Consultees Name: Received: Comment: Response: 2023/5135/P Matteo Sotti 01/02/2024 11:13:19  
OBJ I live on Goldhurst Terrace and my property's land corners the land of 134 Belsize Road. I have analysed the proposed development, and I would like to object to it in relation to the multiple proposed extensions of the rear facade, which overlooks my garden, bedrooms, and kitchen areas. Belsize Road is a road comprised of terraced homes, all aligned in their rear facades, and with very small rear gardens before the boundaries with the gardens of properties on Goldhurst Terrace. As such they are not "extendable" at the rear unless a total loss of their green space and an intrusion towards the properties on Goldhurst Terrace. The proposed development extends the lower ground to less than 1.5 meters from the boundary with almost entire loss of outdoor / green area; but more importantly, the proposed development extends also the raised ground floor by 1.70 meters beyond the aligned walls of the terraced homes, creating a "viewing area" over our gardens and properties from inside 134 Belsize Road raised ground floor, and an associated viewing balcony above the lower ground extension, which b

**Image 4: Illustration of the transparent see-through area**

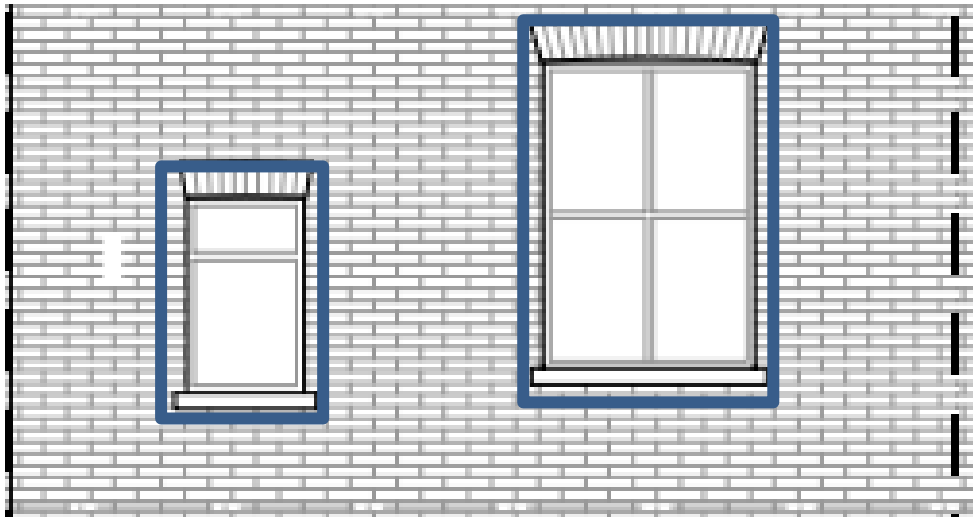
So, if you compare CURRENT CONFIGURATION and PROPOSED CONFIGURATION, Net- Net we are **reducing the see-through window area** (proved from above image 4 using high school math). i.e. we are enhancing privacy and not reducing privacy as wrongly claimed by the commenters on the planning application

**PROPOSED CONFIGURATION** (Window in green will be obscure glazing, so no see – through to help the privacy. The balustrade in red will be obscure glazing as well)

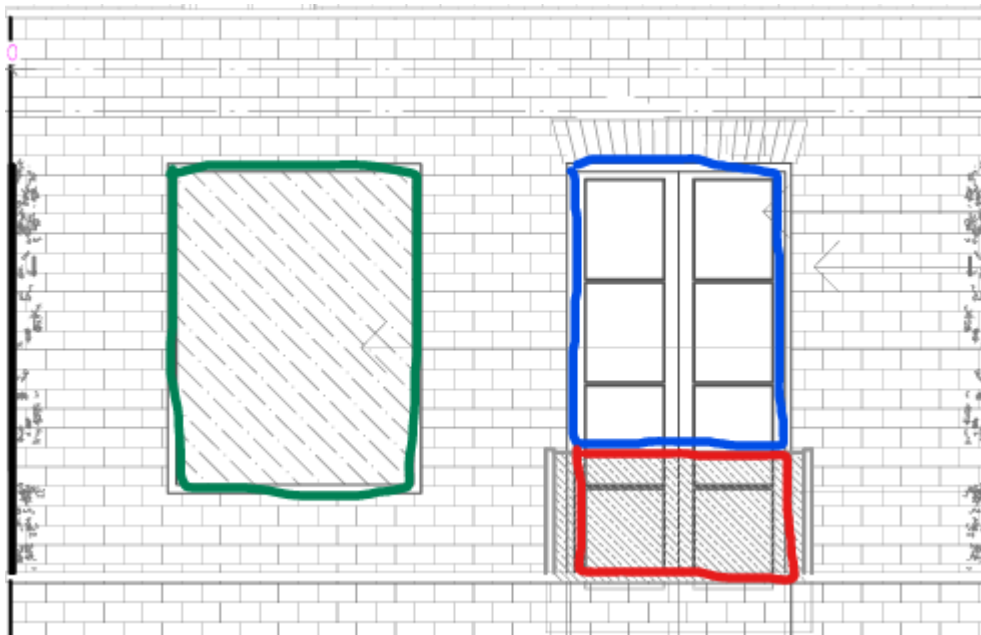
**CURRENT CONFIGURATION** (both the windows at the rear ground floor are made of normal transparent see-through glasses providing full visibility to the rear)

**IMAGE 5: Birds eye view and illustration of current distance with 205 GH nearest bedroom**  
(source: Google)

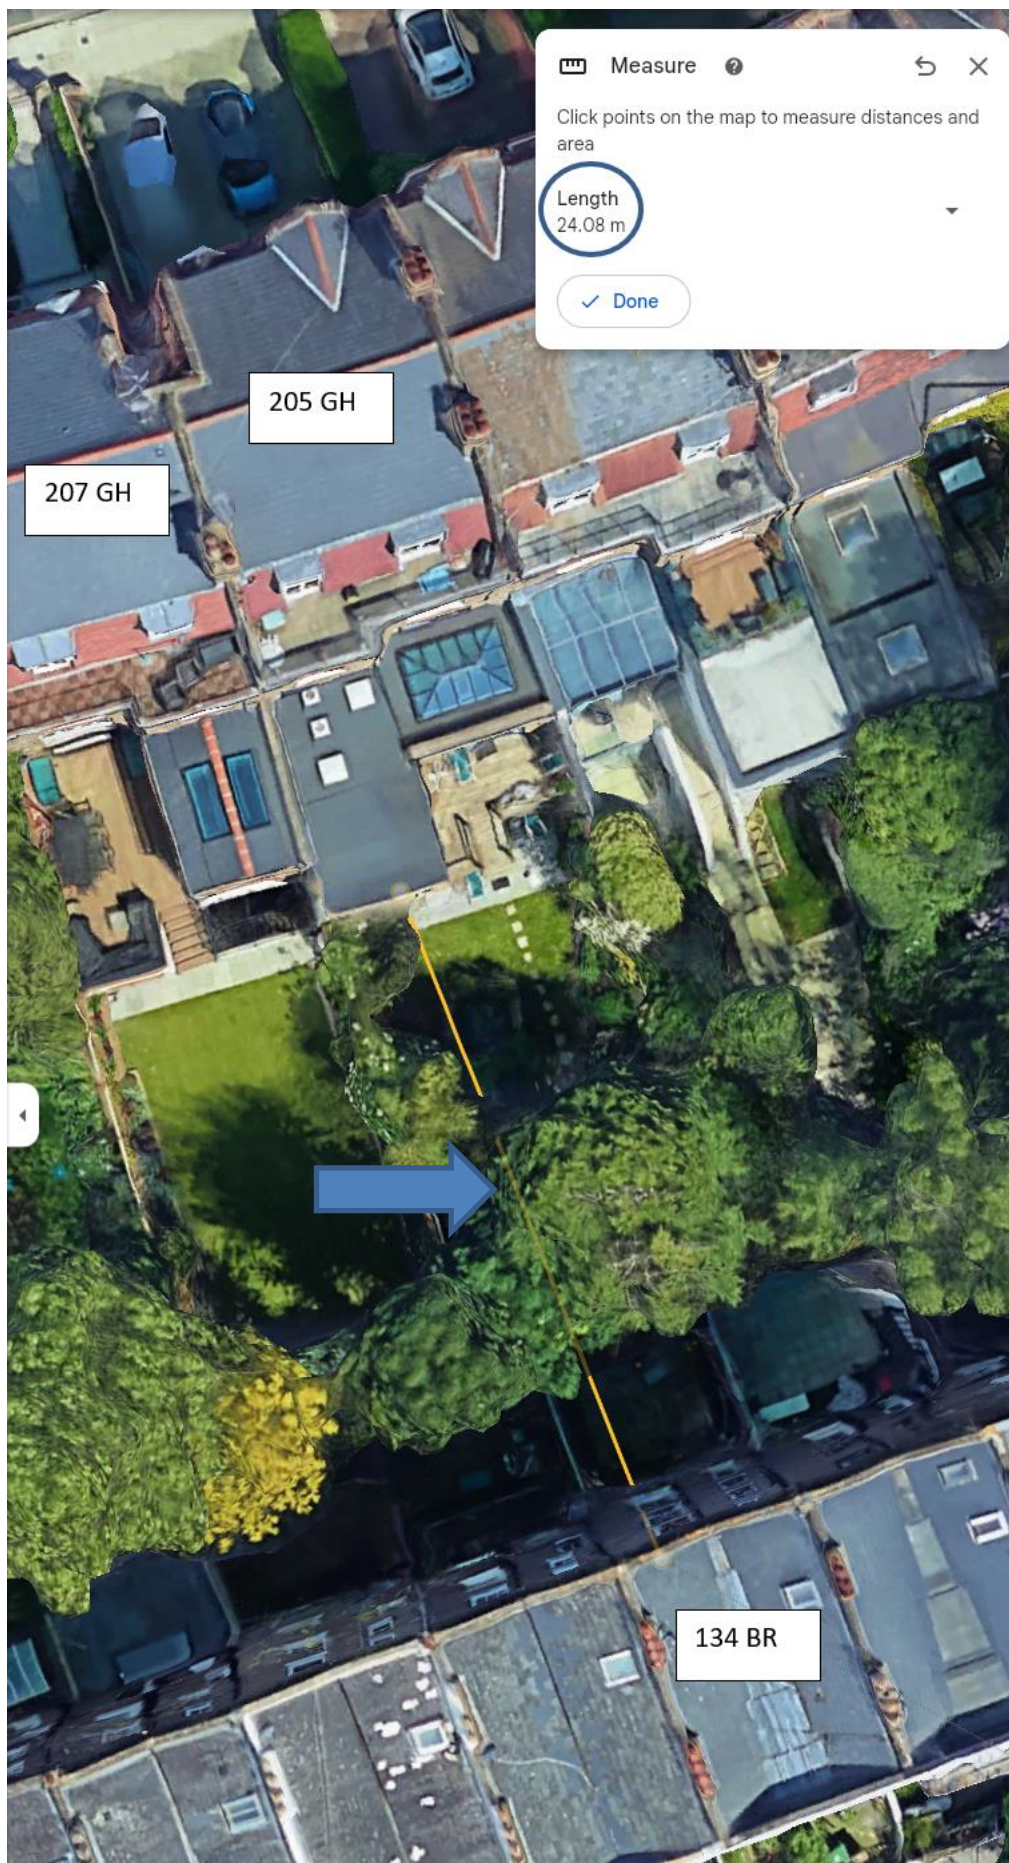
Measured from the professional laser device, the distance of the nearest bedroom wall of 205 Goudhurst terrace is more than 20m away from where the current proposed upper ground extension ends.

**IMAGE 6: Birds eye view and illustration of current distance with 207 GH nearest bedroom (source google)**

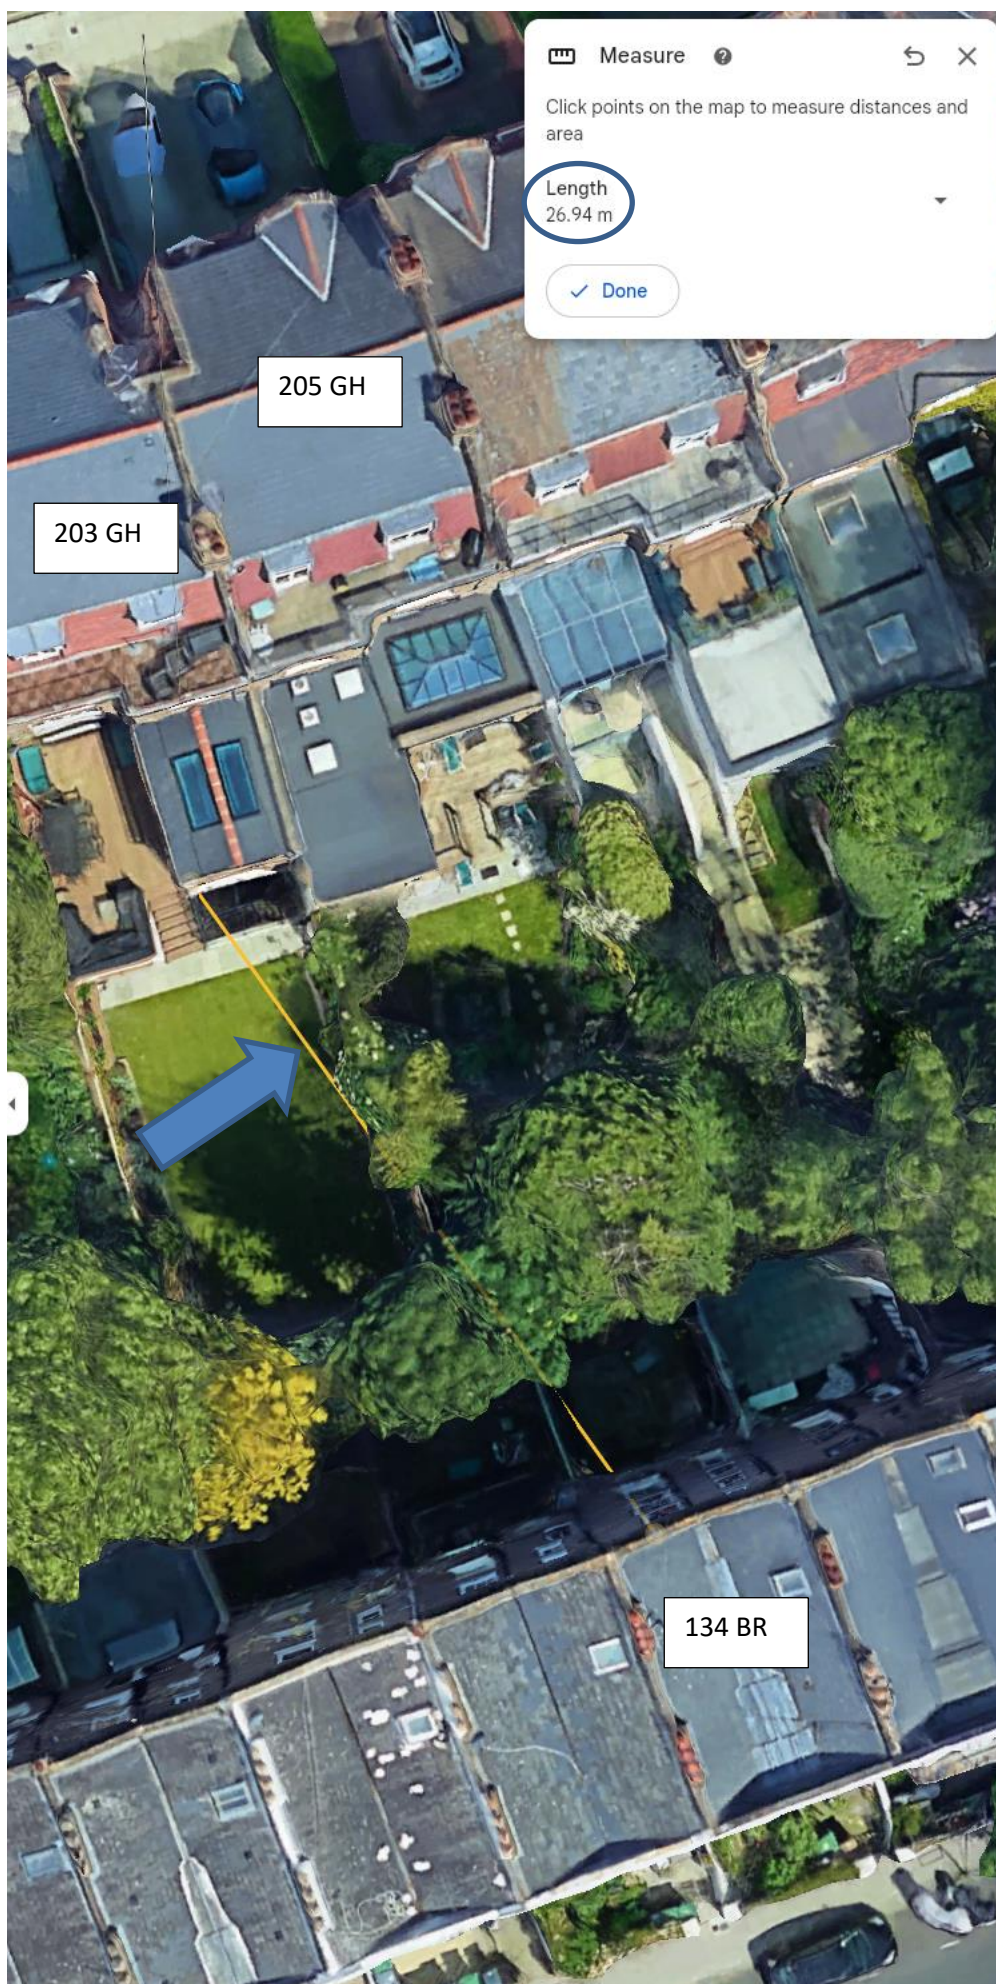
Measured from the professional laser device, the distance of the nearest bedroom wall of 207 Goudhurst terrace is more than 24m away from where the current proposed upper ground extension ends
